## GENUINE MOTOR PARTS AND MOTOR ACCESSORIES BULLETIN

PAB1065

### PAB1065: SCREAMIN' EAGLE MILWAUKEE-EIGHT HIGH-FLOW EXHAUST SYSTEM STATUS UPDATE

Figure 1. Shields

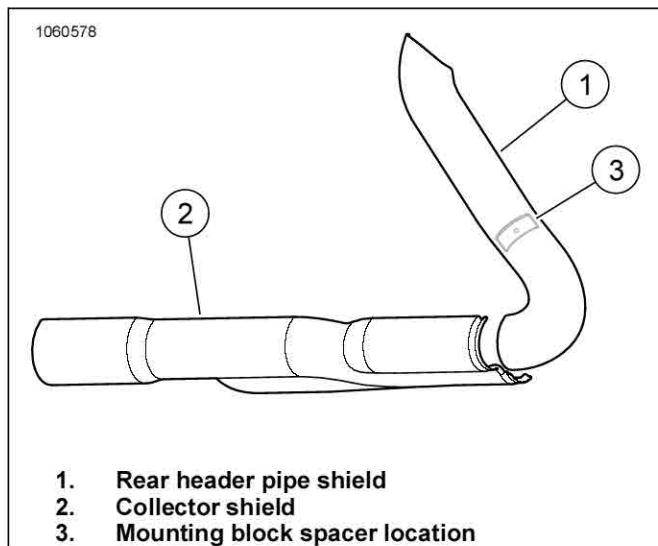
Harley-Davidson has discovered a possible concern with the header pipe shield to collector shield fitment or alignment. If this condition exists, install spacer kit (part no. 65400482) according to the included instruction sheet (-J06608). This spacer kit will be included in all Screamin' Eagle High-Flow Exhaust System kits and will also be available separately. The image below is an example of the spacer kit application:
